Access Compliance Report

Public Rights-of-Way

Intersection ID: 6874	Main Street: CINDY_LN	Cross Street: GRASSET_AV	Location: NE
ADA ID: E5194654CB51	Ramp Type: Directional1	Initial Pass/Fail: Fail	Overall Compliance: No
		Severity Score: 1.25

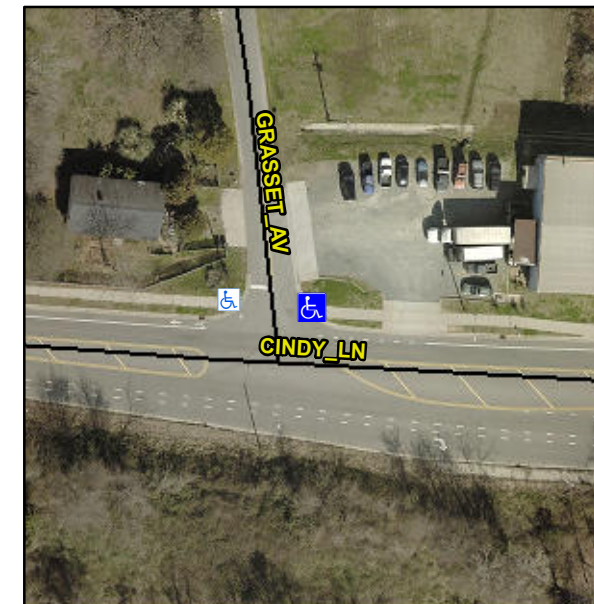
R304.5.3

Compliance	Description	Data	Compliance	Description	Data
N/A	Ramp Length (in)	64.0	N/A	Grade Break?	N/A
Yes	Ramp Width (in)	68.0	N/A	Grade Break Slope (%)	0.0
Yes	Ramp Slope (%)	6.7	N/A	Grade Break XSlope (%)	0.0
No	Ramp XSlope (%)	2.2			
N/A	Flare Type LT	N/A	N/A	Flare Type RT	N/A
N/A	Flare Slope LT (%)	N/A	N/A	Flare Slope RT (%)	0.0
N/A	Flare Traversable LT?	N/A	N/A	Flare Traversable RT?	N/A
N/A	Landing Length (in)	0.0	N/A	DWS Provided?	N/A
N/A	Landing Width (in)	0.0	N/A	DWS Contrast?	N/A
N/A	Landing Slope (%)	0.0	N/A	DWS Length (in)	N/A
N/A	Landing X Slope (%)	0.0	N/A	DWS Full Width?	N/A
N/A	Landing Curb? (Y/N)	N/A	N/A	DWS Offset LT (in)	N/A
N/A	Shared Landing?	N/A	N/A	DWS Offset RT (in)	N/A
N/A	Gutter Ponding?	0.0	N/A	Gutter Slope (%)	N/A
N/A	Gutter Lip Ht (in)	0.0	N/A	Gutter X Slope (%)	N/A
N/A	Painted X Walk1?	No		Road Slope (%)	4.4
	X Walk 1 Direction	To W		Road X Slope (%)	3.3
	X Walk 1 Width (in)	N/A		Clear Space?	N/A

Remove & Replace Entire Ramp.
